STAFF REPORT		
Address:	4101 Manor Rd., Chevy Chase	Meeting Date:	10/11/2023
<b>Resource:</b>	Individually Listed Master Plan Site (Hayes Manor #35/10)	Report Date:	10/4/2023
Applicant:	Howard Hughes Medical Institute (HHMI) Susan Pommerer, Architect	Public Notice:	9/27/2023
<b>Review:</b>	HAWP	Staff:	Dan Bruechert
Permit No.:	1001591 REVISION	Tax Credit:	Partial
Proposal:	Revisions To Previously Approved HAWP for Grading Alterations and updates to limits of dis Investigations		•

#### MONTGOMERY COUNTY HISTORIC PRESERVATION COMMISSION STAFF REPORT

MONTGOMERY COUNTY HISTORIC PRESERVATION COMMISSION REVISED HISTORIC AREA WORK PERMIT (HAWP) APPLICATION #1001591 REVISION 02

Figure 3: Revised site plan showing the new turnaround and bioretention area.

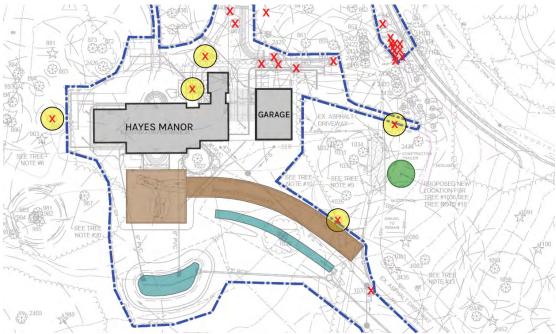
The applicant proposes to revise the proposal by expanding the exposed aggregate concrete paving directly to the south of the house's south entrance (see below). The enlarged area will be large enough to accommodate a three-point turnaround and will be constructed in the same exposed aggregate concrete with a bluestone border that had been approved in the 2022 HAWP.

Staff finds the proposed revision will not have a substantial impact on the character of the site and will result in a net reduction in paving on site. Staff additionally finds that the proposed material is consistent

with the character of the site and the HPC's finding in the approved HAWP. Details regarding the archaeological feature will be incorporated into the final archaeological report and submitted to the historic preservation office. Staff recommends the HPC approve the HAWP under 24A-(b)(2) and Standards 2, 9, and 10.
